## 7.2 Reactor Protection (Trip) System (RPS)—Instrumentation and Controls

The information in this section of the reference ABWR DCD, including all subsections, tables and figures, is incorporated by reference with the following departures and supplements.

STD DEP T1 2.3-1 (Table 7.2-1, 7.2-2, Figures 7.2-2, 7.2-6, 7.2-9, 7.2-10)

Figure 7.2-2 Reactor Protection System Equipment Arrangement (From Sensors Through Trip Actuators)

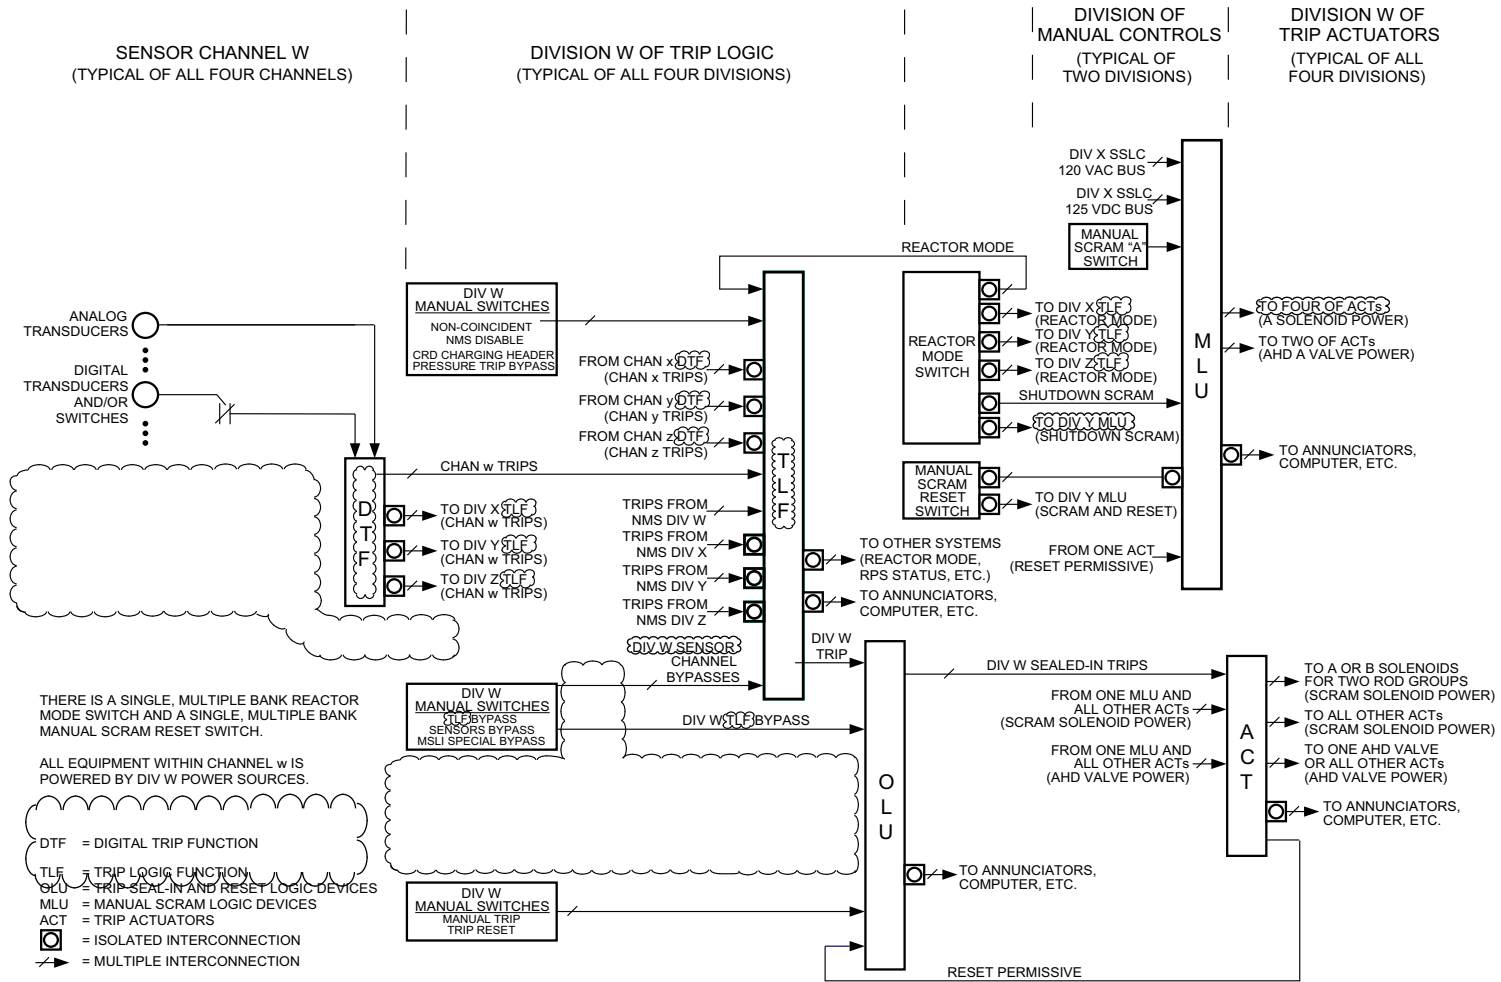
STD DEP T1 3.4-1 (Figures 7.2-2, 7.2-9, 7.2-10)

The RPS equipment is divided into four redundant divisions of sensor (instrument) channels, trip logics and trip actuators, and two divisions of manual scram controls and scram logic circuitry. The sensor channels, divisions of trip logics, divisions of trip actuators and associated portions of the divisions of scram logic circuitry together constitute the RPS scram and air header dump (backup scram) automatic initiation logic. The divisions of manual scram controls and associated portions of the divisions of scram logic circuitry together constitute the RPS scram and air header dump manual initiation logic. The automatic and manual scram initiation logics are independent of each other. RPS equipment arrangement is shown in Figure 7.2-2.

Equipment within a sensor channel includes primarily sensors (transducers or switches), ~~multiplexers and digital trip modules (DTMs)~~ trip functions (DTFs). The sensors within each channel monitor plant variables (Subsection 7.2.1.1.4.2) ~~and send either analog or discrete output to remote multiplexer units (RMUs) within the associated division of Essential Multiplexing System (EMS) the DTF.~~ Each division of the EMS performs analog to digital conversion on analog signals and sends the digital or digitized analog output values of all monitored variables to the DTF within the associated RPS sensor channel. The ~~DTM DTF~~ in each sensor channel compares individual monitored variable values with trip setpoint values and for each variable sends a separate, discrete (trip/no trip) output signal to all four divisions of trip logics.

Equipment within a division of trip logic includes primarily manual switches, ~~bypass units (BPUs)~~ bypass interlock functions, trip logic units functions (TLUs/TLFs) and output logic units (OLUs). The various manual switches provide the operator means to modify the RPS trip logic for special operation, maintenance, testing and reset. The ~~BPUs~~ bypass interlock functions enforce restrictions on bypassing multiple divisions of related functions. The bypass interlock functions perform bypass and interlock logic for the channel sensors bypass, main steamline isolation trip special bypass and division trip logic unit bypass. These three bypasses are all manually initiated through individual

~~keylock bypass~~ switches within each of the four divisions. Each ~~BPU bypass switch~~ sends a separate bypass signal for all four channels to the ~~TLUTLE~~ in the same division for channel sensors bypass and MSL isolation trip special bypass. Each ~~BPU bypass switch~~ sends the ~~TLUTLE~~ bypass signal to the OLU in the same division.

Figure 7.2-6 Division 1 Trip Logic

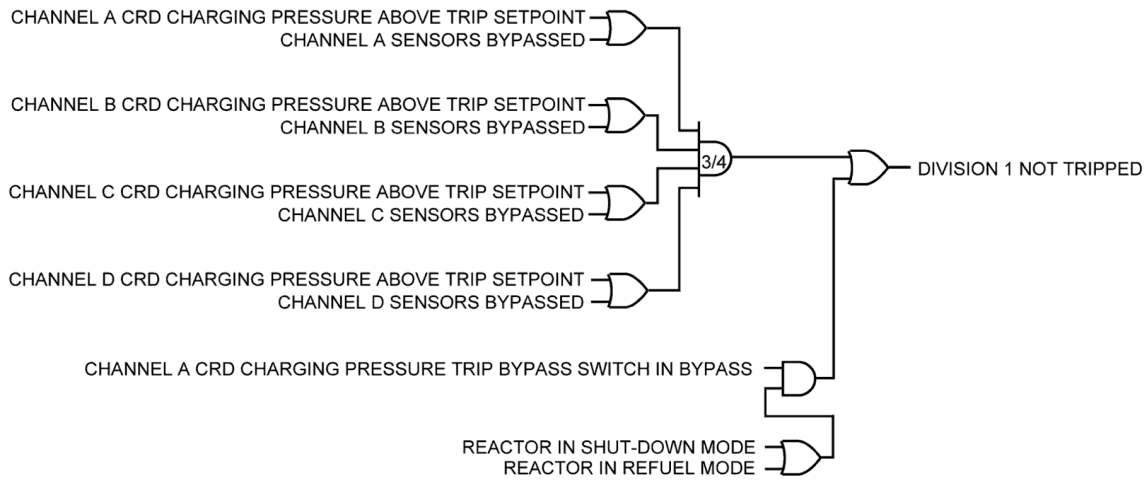
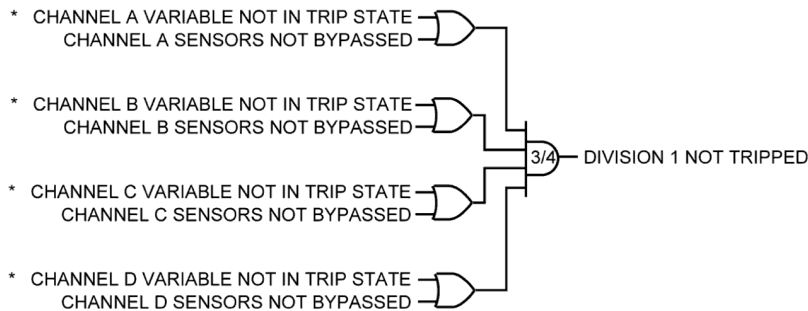
(4) ~~Process Radiation Monitoring (PRM) System (Figure 7.2-6)~~ Not Used

~~High Main Steamline Radiation Trip (Figure 7.2-6)~~

~~A high main steamline radiation trip will occur in each division of trip logic when a main steamline radiation trip condition exists in any two or more unbypassed sensor channels. There are no operating bypasses associated with this trip function.~~
